# Highway Changes Prompted by 2026 Mileage Certificates

# Vermont Agency of Transportation

Wednesday, May 27, 2026

**Mileage Certificate Changes 2026**  
**PANTON TH-14**  
 (CTUA:0115-0)  
 (CERTCODE:0115-0)

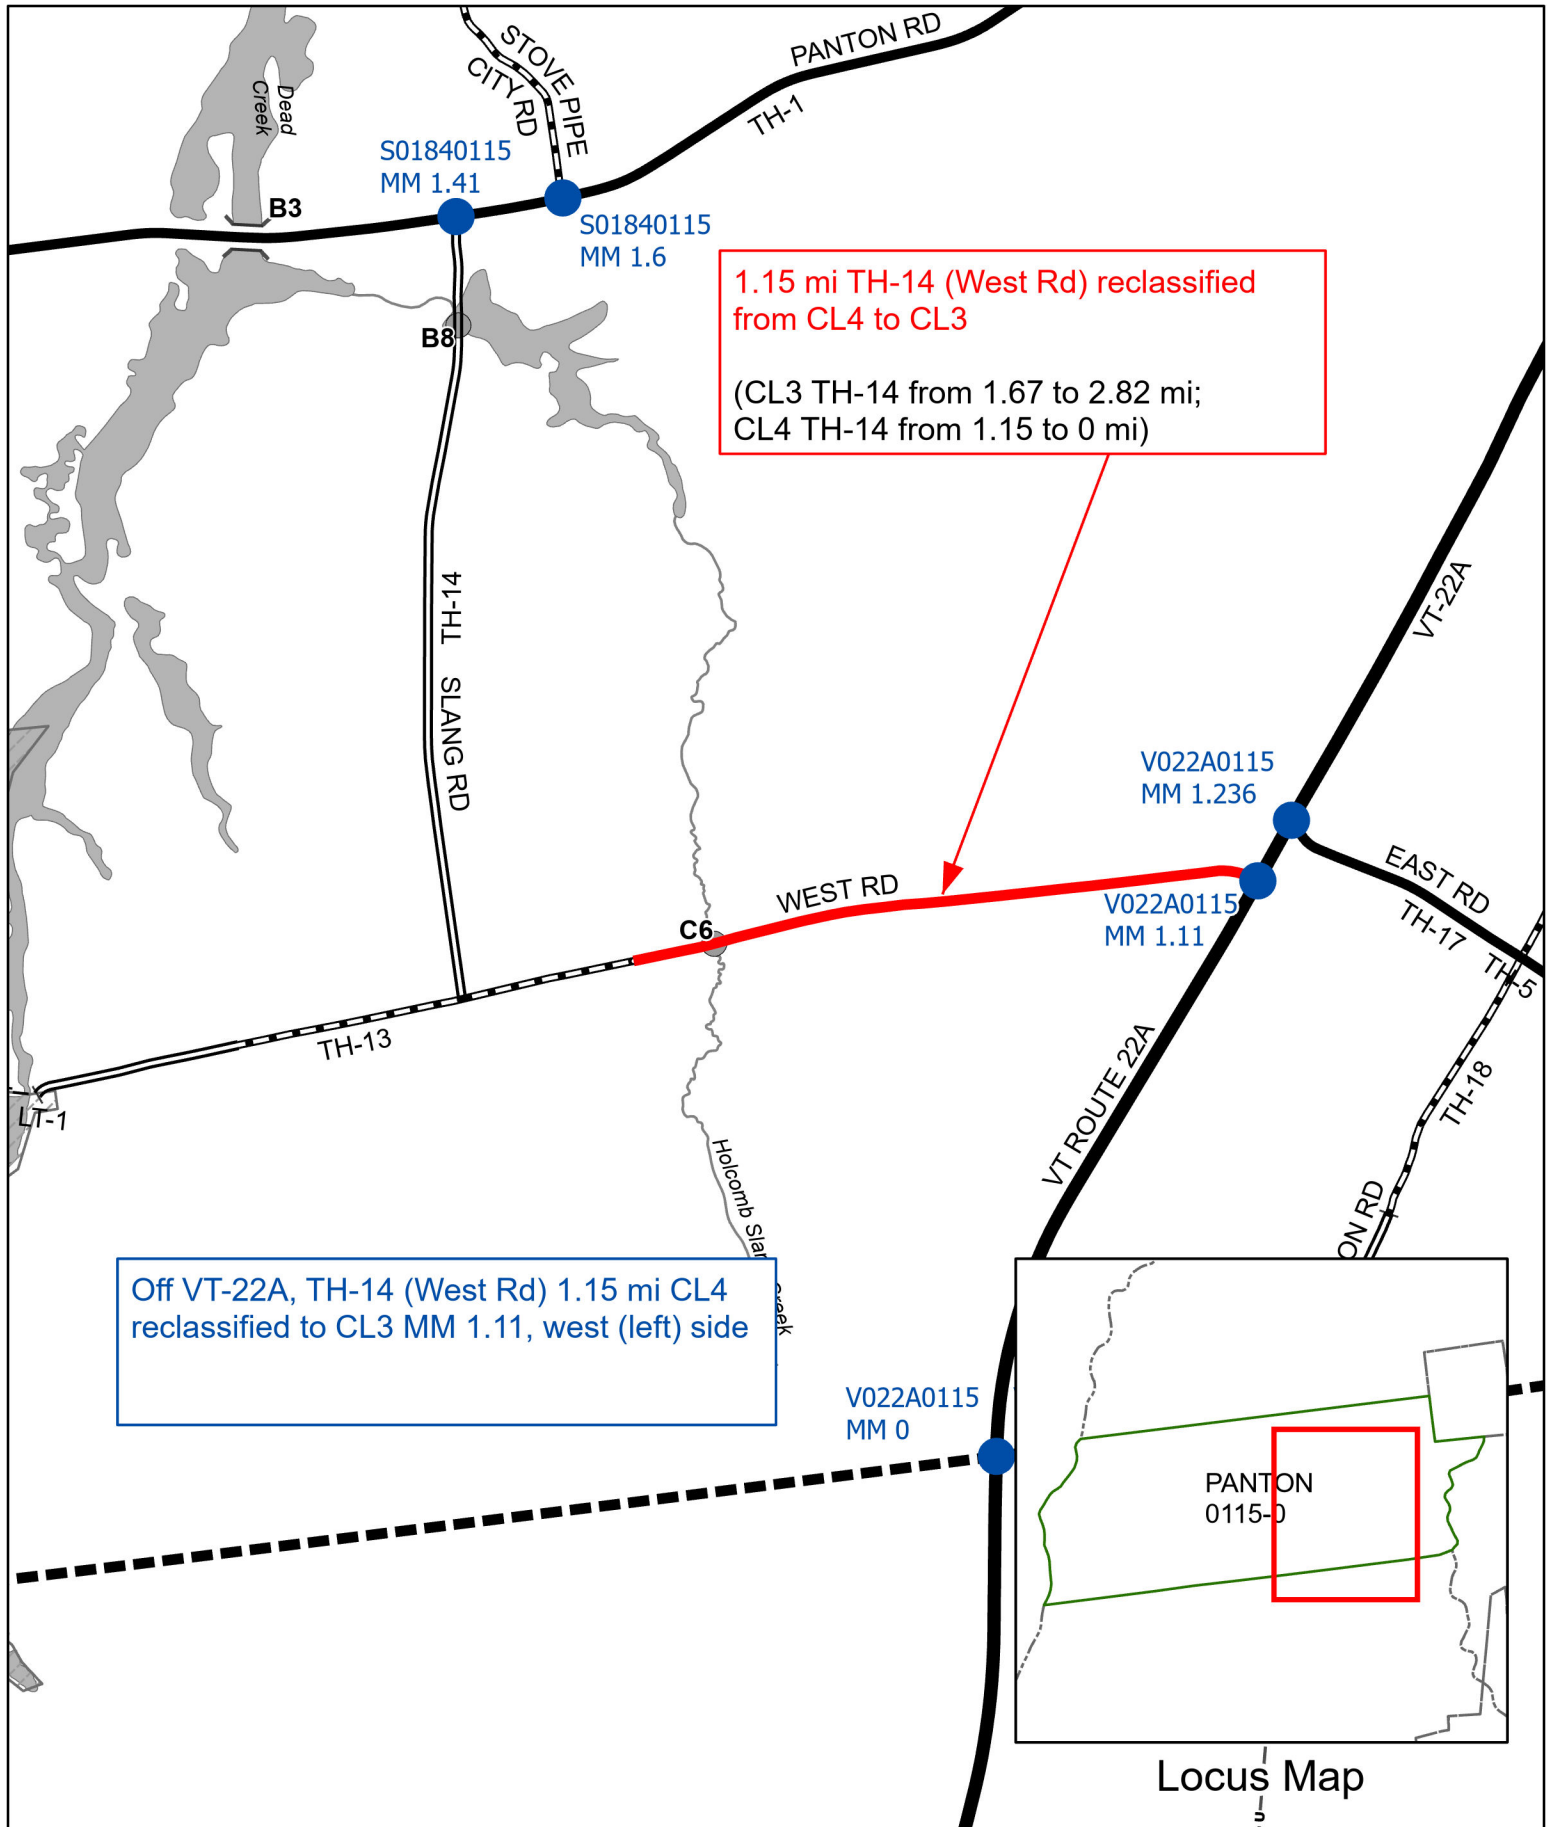
County	Town	New Highway Mileage	Reclassified/Remeasured	Discontinued Mileage	VTrans Notes
ADDISON	PANTON		1.15 mi TH-14 (West Rd) reclassified from CL4 to CL3		Off VT-22A, TH-14 (West Rd) 1.15 mi CL4 reclassified to CL3 MM 1.11, west (left) side
BENNINGTON	BENNINGTON	VT-67A roundabout reconfiguration at intersection with TH-11 (Matteson Rd) and TH-26 (Silk Rd) (no mileage change) 0.28 mi CL3 TH-512 (Duffy Dr) new road; 0.10 mi CL3 TH-513 (Jayne Ln) new road; 0.12 mi CL3 TH-514 (Hildur Hl) new road			VT-67A roundabout reconfiguration at intersection with TH-11 (Matteson Rd) and TH-26 (Silk Rd) between MMs 1.019 to 1.134
BENNINGTON	POWNAI	+0.017 mi CL2 TH-2 approach (S0103WA001) added not previously mapped approach at VT346 +0.23 mi TH-24 (Dean Rd) extension designated CL3 Provisional pursuant to 19 VSA 302c	-0.017 mi CL2 TH-2 (N Pownal Rd, S0103) remeasured to 3 decimal places 1.01 mi CL3 TH-5 (Carpenter Hill Rd West) designated NUTS designated Not Up To Standard (NUTS) pursuant to 19 VSA 305(a) 0.10 mi CL3 TH-45 (Orchard St) designated Not Up To Standard (NUTS) pursuant to 19 VSA 305(a)		No net mileage change for CL2 TH-2

**Mileage Certificate Changes 2026  
BENNINGTON VT-67A**

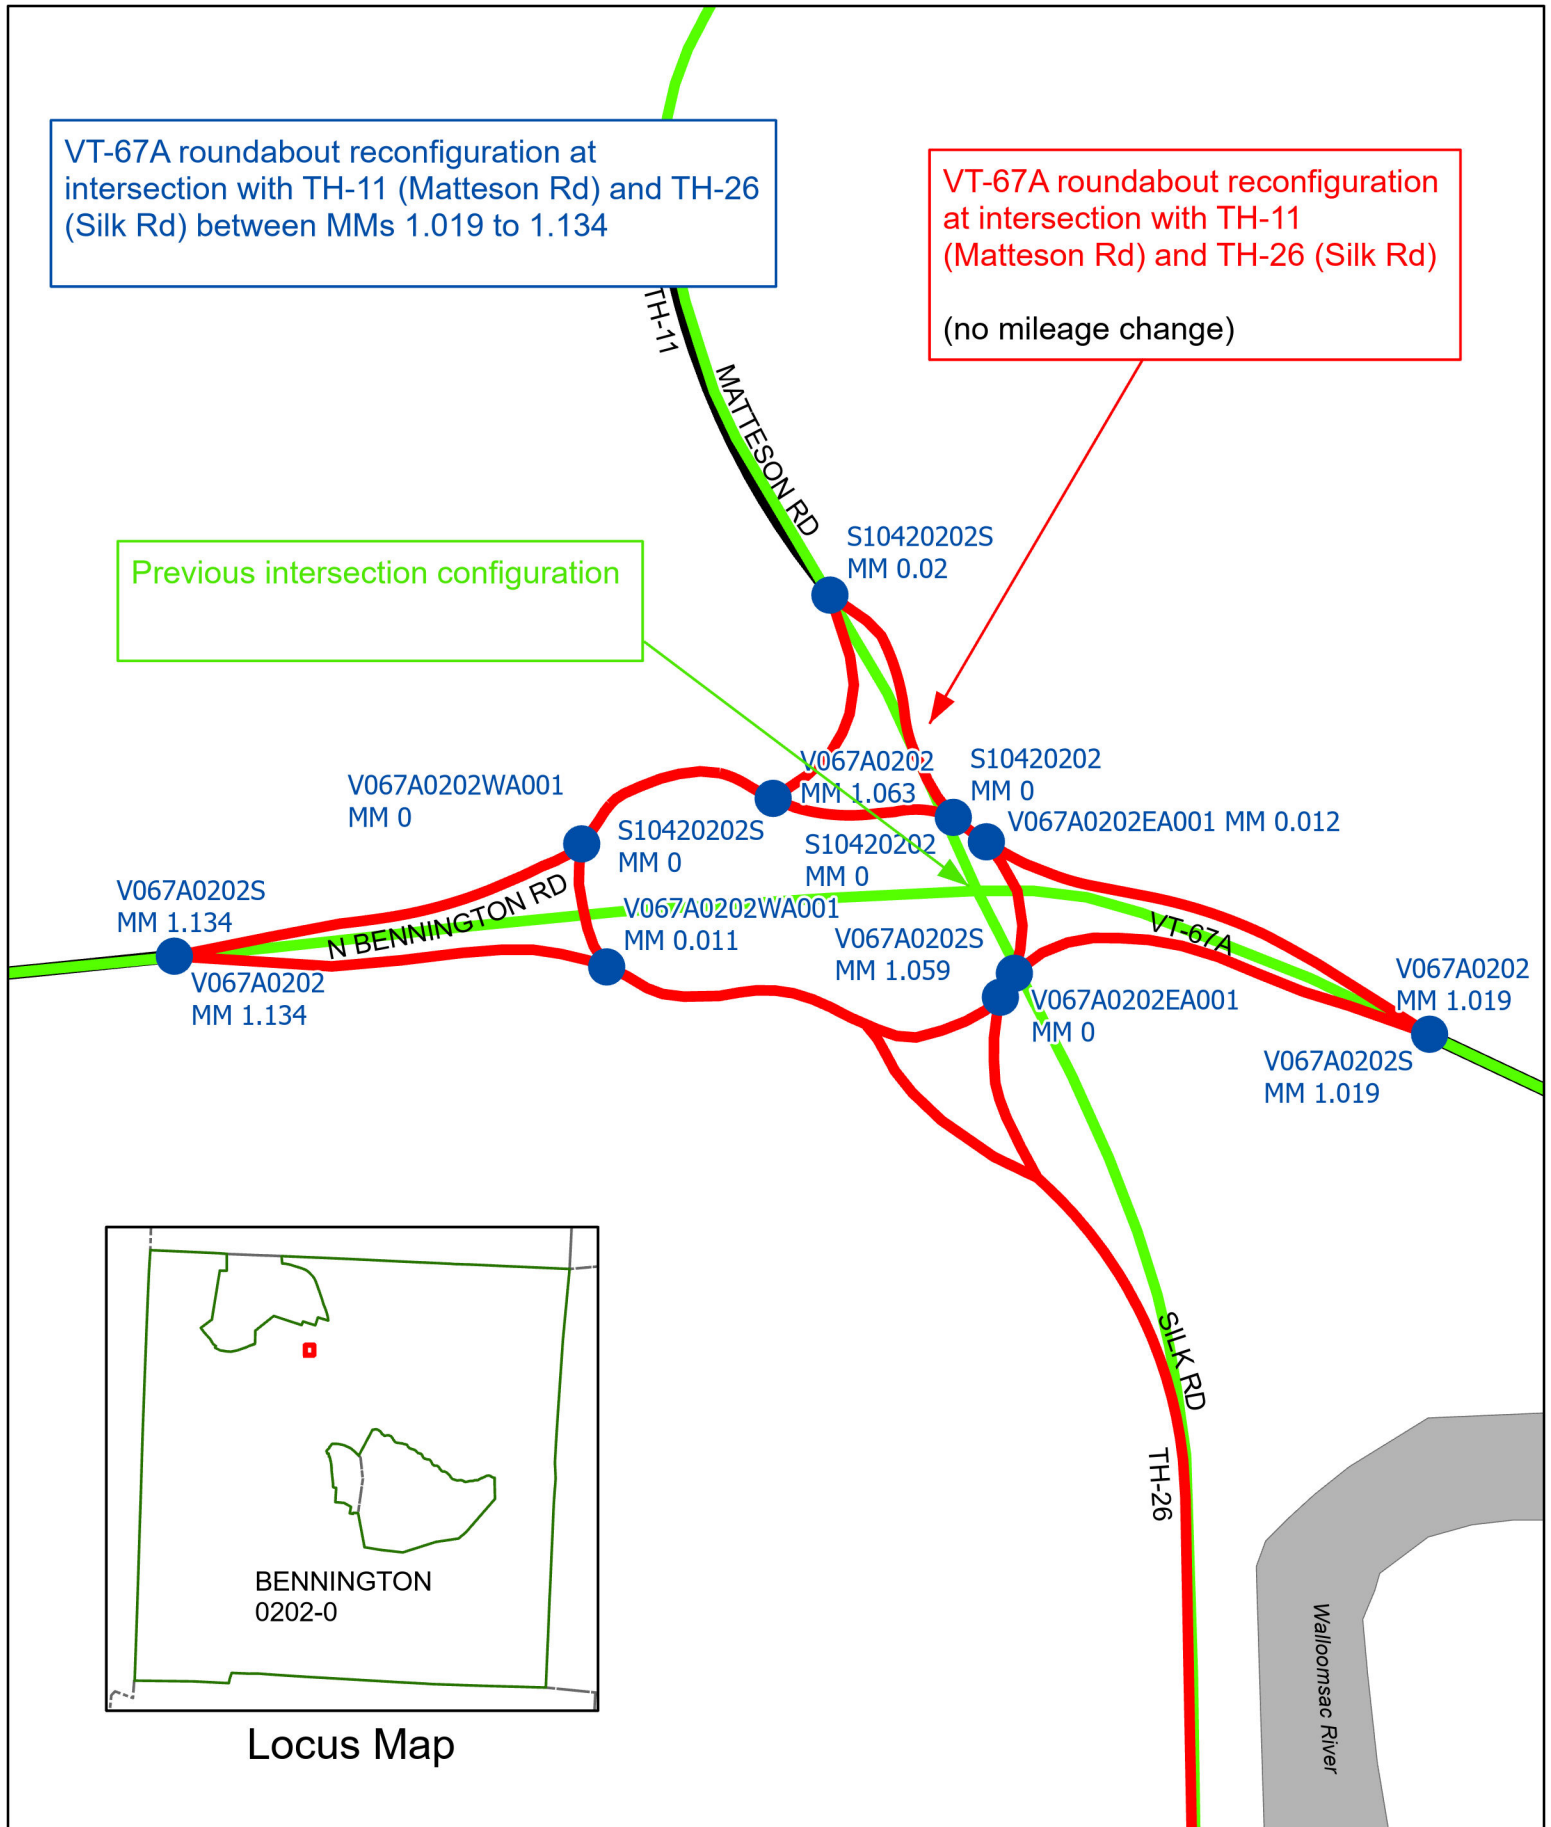
VT-67A roundabout reconfiguration at intersection with TH-11 (Matteson Rd) and TH-26 (Silk Rd) between MMs 1.019 to 1.134

VT-67A roundabout reconfiguration at intersection with TH-11 (Matteson Rd) and TH-26 (Silk Rd) (no mileage change)

**Mileage Certificate Changes 2026**  
**COLCHESTER**

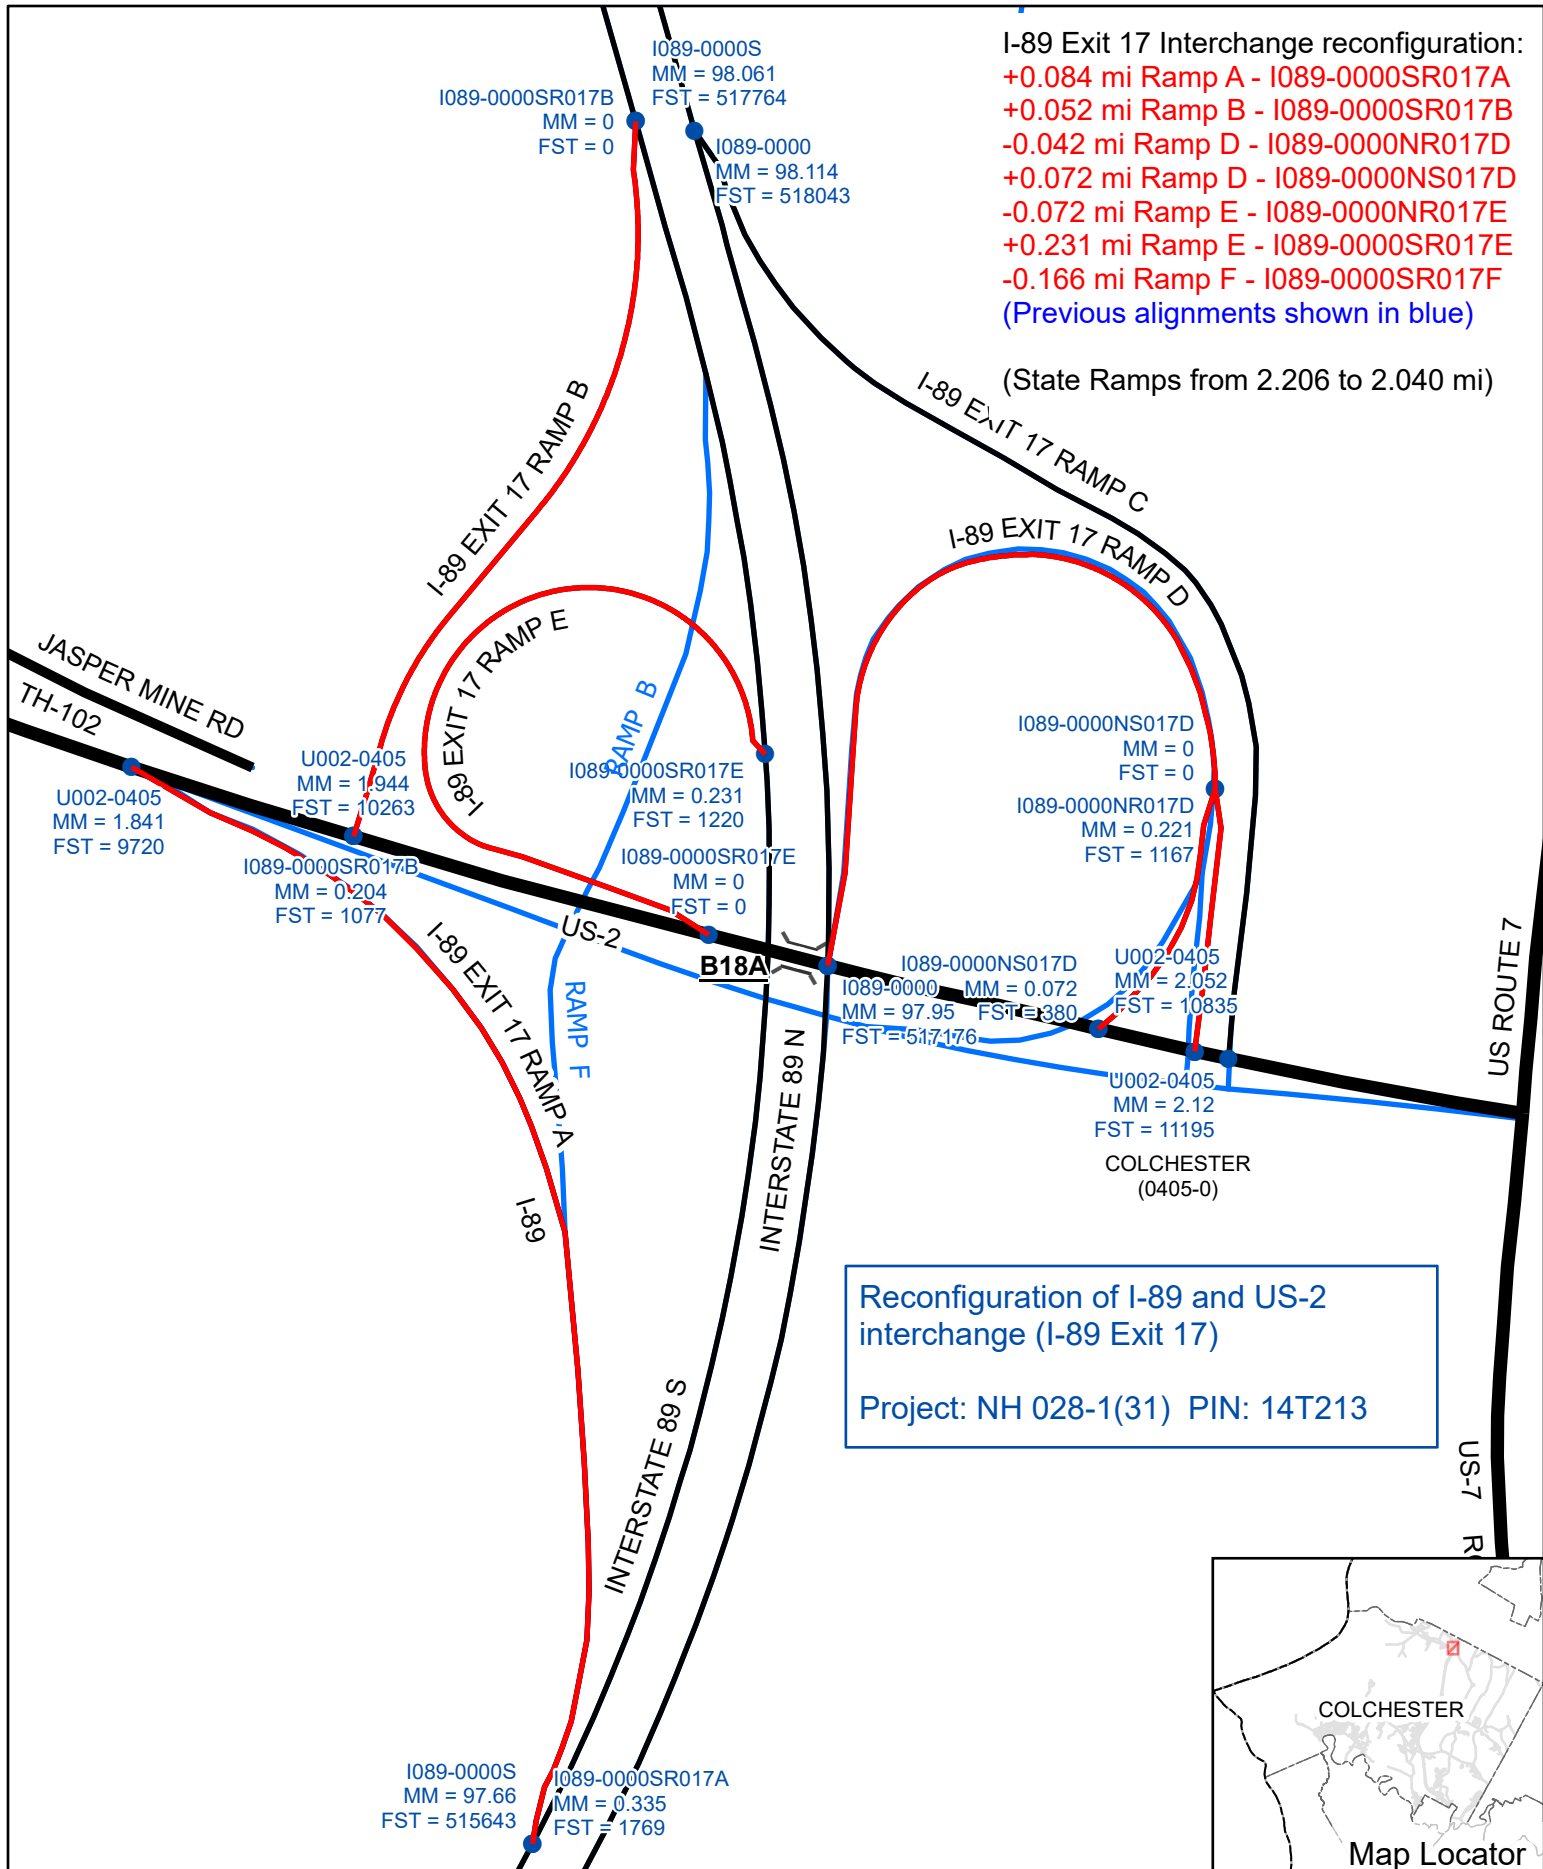
**I-89 Exit 17 Interchange reconfiguration:**  
 +0.084 mi Ramp A - I089-0000SR017A  
 +0.052 mi Ramp B - I089-0000SR017B  
 -0.042 mi Ramp D - I089-0000NR017D  
 +0.072 mi Ramp D - I089-0000NS017D  
 -0.072 mi Ramp E - I089-0000NR017E  
 +0.231 mi Ramp E - I089-0000SR017E  
 -0.166 mi Ramp F - I089-0000SR017F  
 (Previous alignments shown in blue)

(State Ramps from 2.206 to 2.040 mi)

Reconfiguration of I-89 and US-2 interchange (I-89 Exit 17)  
 Project: NH 028-1(31) PIN: 14T213
